Z-1  
(2015)

MARS HILL ROAD  
TRACT  
LAND LOT 186 & 195, 20TH DISTRICT, 2ND SECTION,  
COBB COUNTY, GEORGIA

**PETITION NO:** Z-1

**ZONING COMMENTS:**

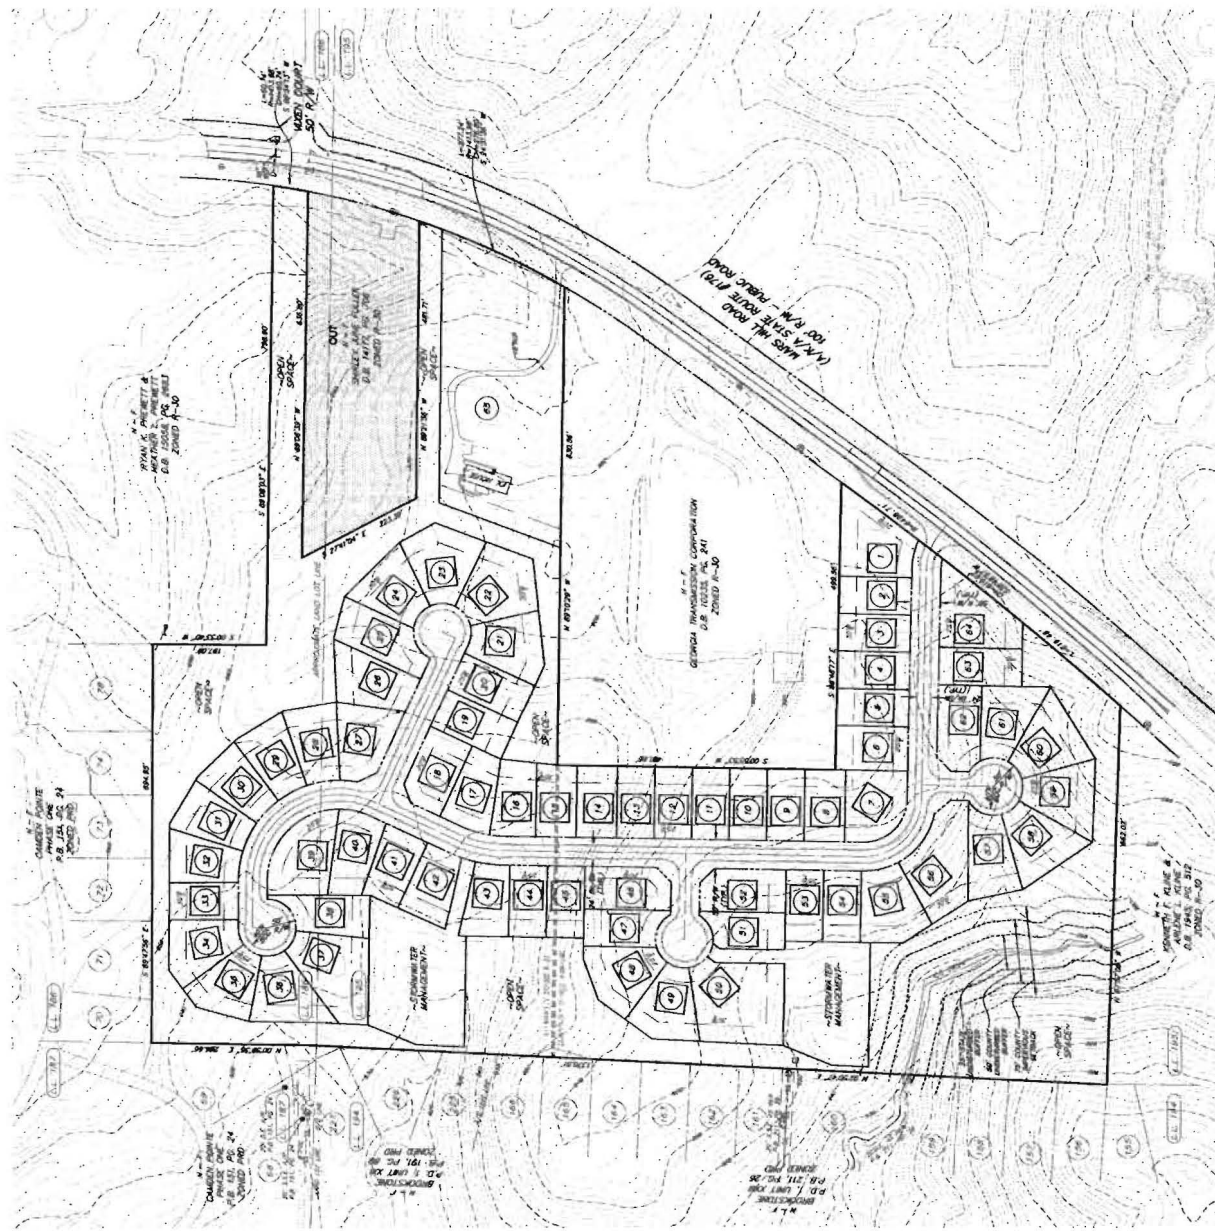
1. Current density exceeds future land use guidelines. Please provide plan with density that is consistent with the VLDR range (1 to 2 upa).
2. Provide pedestrian easement(s) of at least 15 feet wide to allow access of commonly owned open space.

1. A drainage easement will be required at the rear of lots 37-39 to limit offsite runoff bypass.
2. Elevated erosion control measures including a mulch berm along the rear of lots 24-26 will be required to protect the downstream lake within Camden Pointe Subdivision.
